Revised 6/1/94 Destroy all previous copies

Introduction

Batten Reflex Modification

Figure no. 1

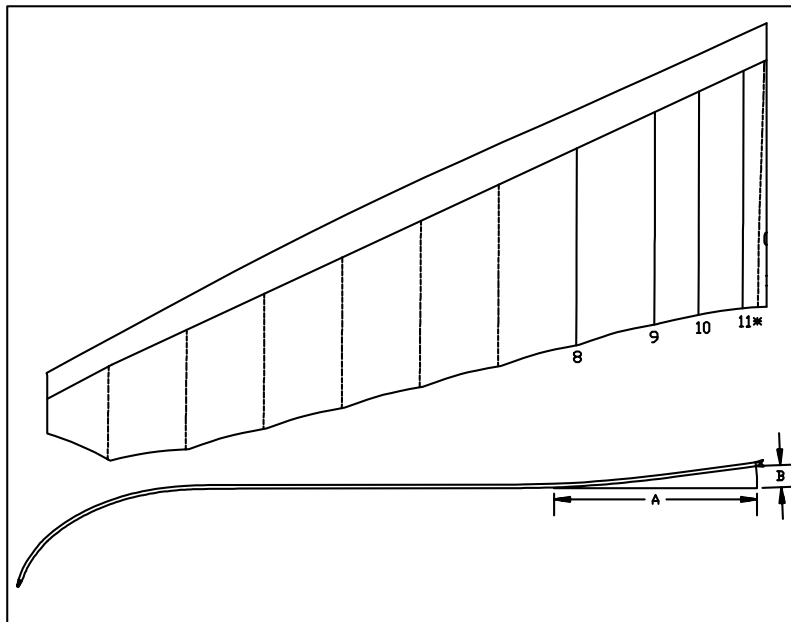
The 154 has reflex added to 4 battens: no. 8 through no. 11, the 146 has reflex added to 3 battens: no. 8 through no. 10. Refer to figure no. 1. Measure and mark each batten at distance "A". Bend each batten in a smooth radius over a 3 inch length centered on the mark. Verify the reflex specification "B" using the replacement batten chart available from Wills Wing. Use the X's, and the unchanged root and #7 battens to align the overlays to the chart. Use care to keep the reflex bend in the same plane as the nose area camber. You will achieve better quality results if you work on a large flat unobstructed surface.

Batten	#8	#9	#10	#11 (154 only)
Distance A	12 in [30.5 cm]	13 in [33 cm]	14 in [35.5 cm]	15.5 in [40 cm]
Distance B RamAir 154	1 in [2.5 cm]	1-1/2 in [3.8 cm]	1-3/4 in [4.5 cm]	2-1/8 in [5.5 cm]
Distance B RamAir 146	1-3/8 in [3.5 cm]	1-3/4 in [4.5 cm]	2-1/4 in [5.7 cm]	NA

Figure no. 3 — Modified Configuration

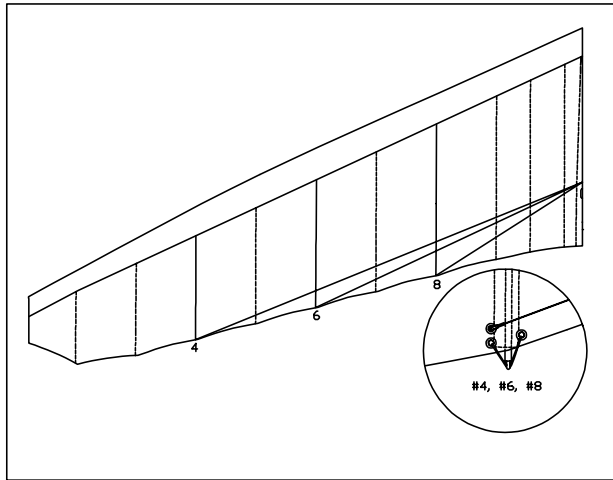
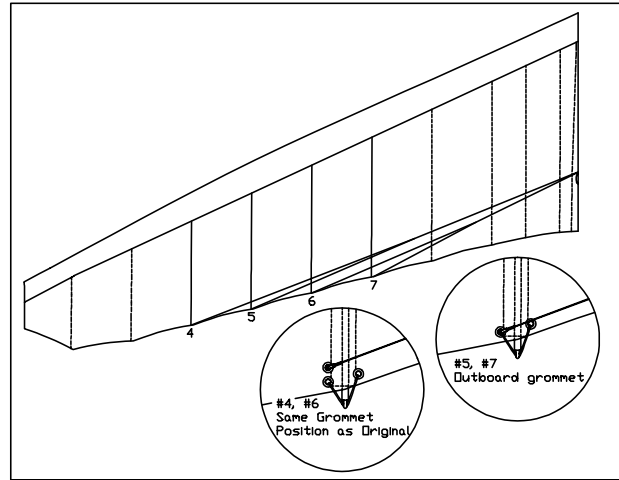
Remove the original bridle set from the #4, #6 and #8 batten stations. Save the 6 bridle balls. Install the retrofit bifurcated bridle set at the #4, #5, #6 and #7 stations. Install the cable loops through the original bridle anchor grommets at the #4 and #6 stations, and through the outboard of the two batten tension grommets at the #5 and #7 stations. Refer to figures no. 2 and no. 3. Check that

all cables are free from twists. Be sure to pre-flight the bridles at the #5 & #7 battens carefully, as there is an increased chance of the bridle ball not fully seating in the grommet because of the batten string. *Please return your original bridle set to Wills Wing.*

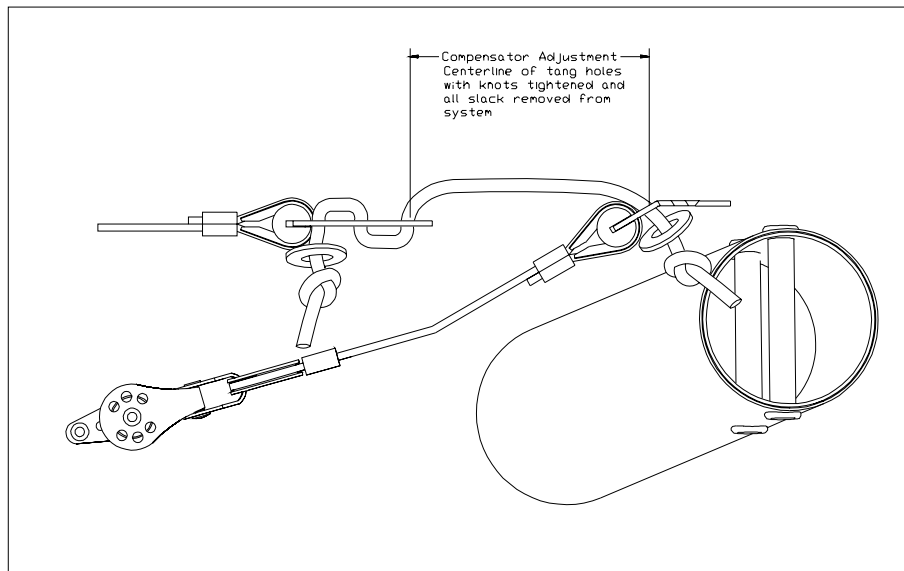
Adjust the perlon rope compensator link (near the crossbar junction) to the following specifications, measured between the centers of the holes in the tangs. Refer to the illustration below. *Use overhand knots only—previous "figure 8" type knots have been known to slip.*

Tighten both knots firmly, using pliers if necessary. Support the rear keel at the rear wire station and pull down on the bridle compensator clip at the top of the kingpost with 50-75 lbs of force. Recheck the specification.

Set the VG to the full loose setting. Check the bridles at each batten station by hooking a tape measure over the top front wire at the kingpost top and reading the measurement at the trailing edge hem, at the intersection with the pencil line on the sail which marks the batten pocket application line. Your measurements should be those shown below, plus or minus 1/4 inch.

RamAir 154 2.75 inches / 7.0 cms

RamAir 146 4.75 inches / 12.0 cms

Model	#7	#6	#5	#4
RamAir 154	97 in [246.4 cm]	117-1/4 in [297.8 cm]	138-1/2 in [351.8 cm]	160-1/8 in [406.7 cm]
RamAir 146	93 in [236.2 cm]	113 in [287 cm]	134 in [340.4 cm]	155-1/2 in [395 cm]

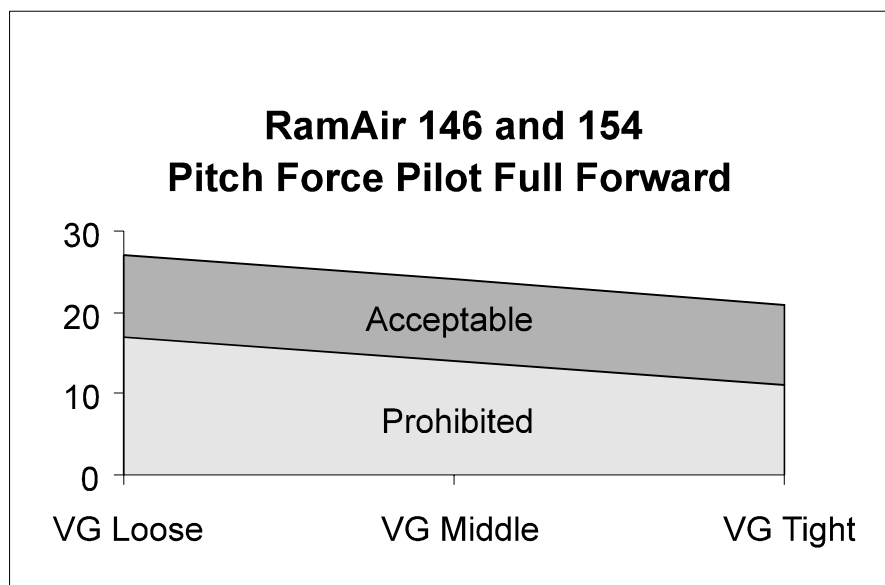
Reflex slows the glider trim speed approximately three mph. Mark the location of the rear of the hangloop on the keel. Adjust the hang loop 1/2 inch forward. Check that the forward hang loop adjustment tang is pinched firmly against the keel so loop can not shift position.
